## DEVELOPMENT APPLICATION ASSESSMENT REPORT

<b>Application Number:</b>	DA2022/0661
----------------------------	-------------

<b>Responsible Officer:</b>	Grace Facer
<b>Land to be developed (Address):</b>	Lot 1 DP 11936, 29 Woodbine Street NORTH BALGOWLAH NSW 2093
<b>Proposed Development:</b>	Alterations and additions to a dwelling house
<b>Zoning:</b>	Warringah LEP2011 - Land zoned R2 Low Density Residential
<b>Development Permissible:</b>	Yes
<b>Existing Use Rights:</b>	No
<b>Consent Authority:</b>	Northern Beaches Council
<b>Land and Environment Court Action:</b>	No
<b>Owner:</b>	Kieran Alexander Adams Rachael Leigh Adams
<b>Applicant:</b>	Tag Team Constructions Pty Ltd

**Figure 1. West Elevation (red highlighting building envelope numerical non-compliance)**

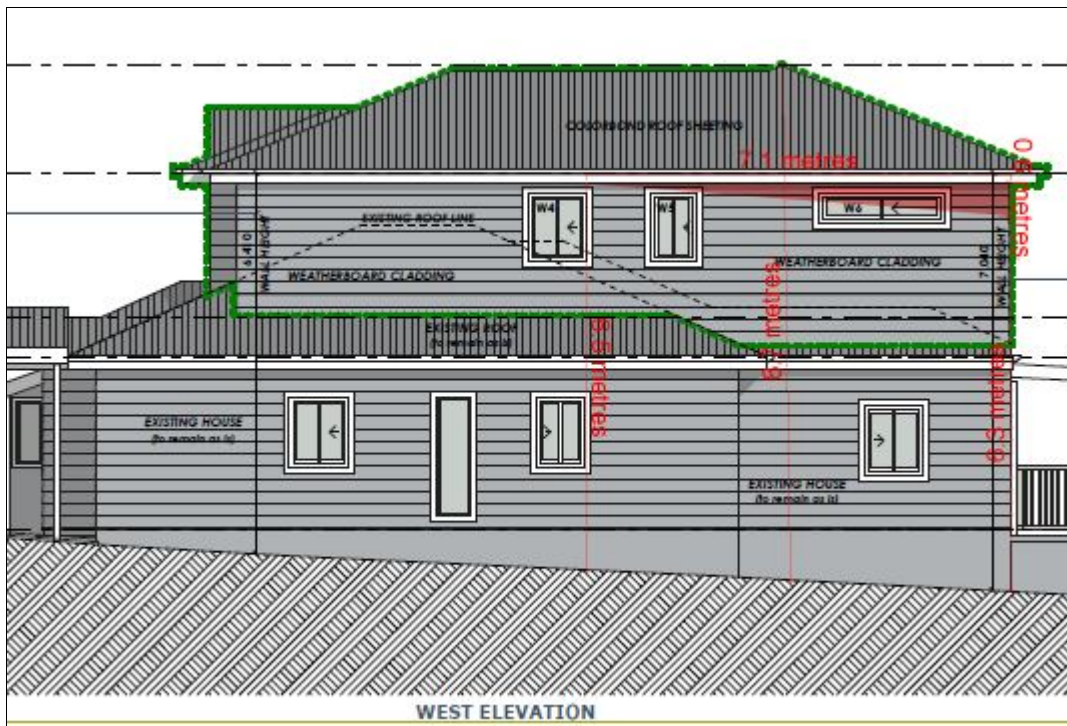
The proposed first floor addition encroaches into the western side boundary envelope to a minor extent within the roof space, resulting in a variation of 9.52% (0.6m) (see Figure 1). The breach diminishes to full compliance along the rise of the land towards the rear of the property.

The proposed first floor addition has minimised the scale and bulk of the building through articulation of the design, inclusion of an open deck, and an increase in the front setback.

The proposed development allows for adequate separation between dwellings and it is not anticipated to result in any unreasonable loss of privacy or over shadowing to surrounding dwellings.

The proposed addition integrates into the form and architectural character of the existing dwelling. The existing dwelling is elevated due to the topography of the site, and follows the contours of the land.

Environmental Planning and Assessment Act, 1979. Accordingly, this assessment finds that the proposal is supported, in this particular circumstance.
